Committee Report

Planning Committee South – 26 October 2021

Application no DC/20/3362/FUL

Land West Side Of
Chapel Road
Grundisburgh
Suffolk

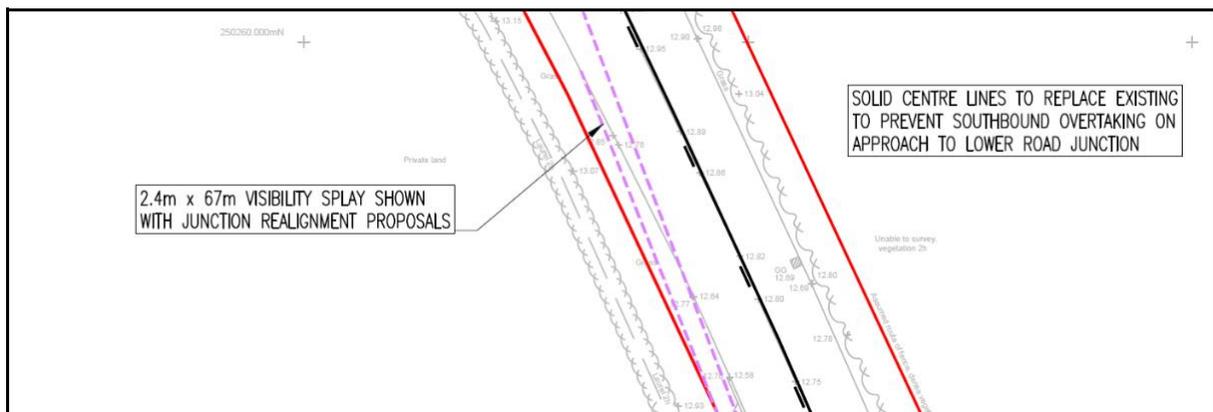
Notwithstanding, in order to expedite the Councils decision making process, swept path analysis drawings have been prepared and are included at Appendix A The Swept paths are based on vehicle details provided by Norse Group who provide the local services to East Suffolk and Grundisburgh. They show the refuse vehicle tracking of the submitted layout allows for the vehicle to enter and leave in a forward gear.

Action Point 5

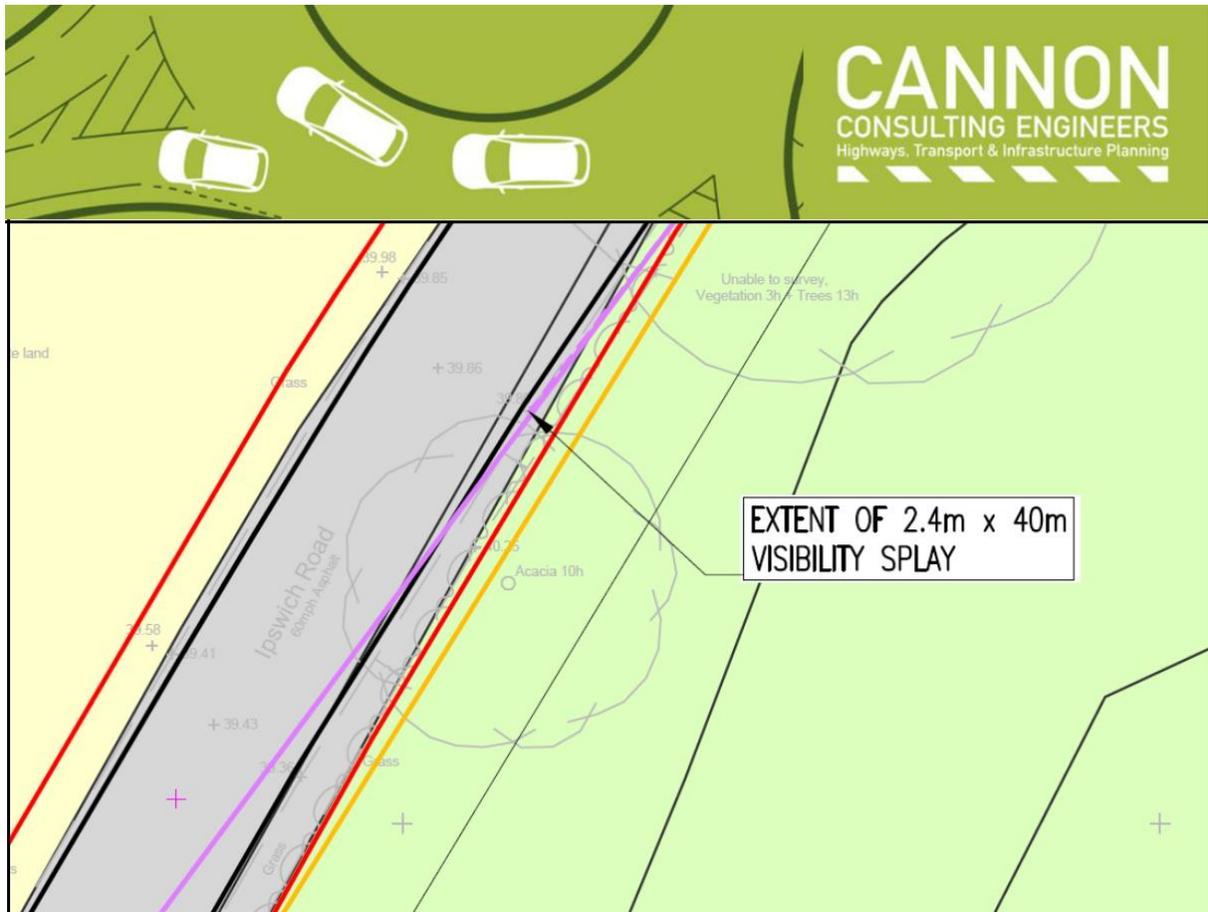
2.33 Provide visibility splays in compliance to design standards.

CCE Response

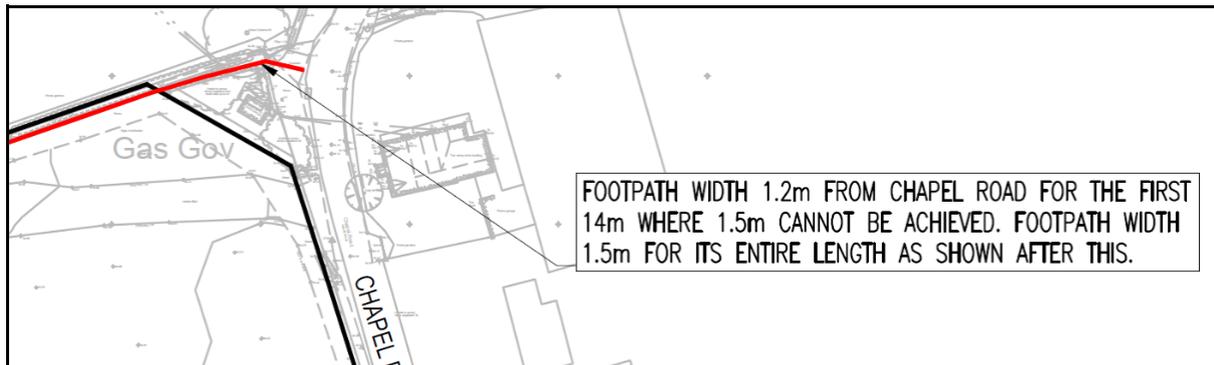
2.73 FP20 should be widened to 1.5m on the entirety

2.74 The accepted improvement to FP20 which is within the defined route includes a short section of 14m which is 1.2m.
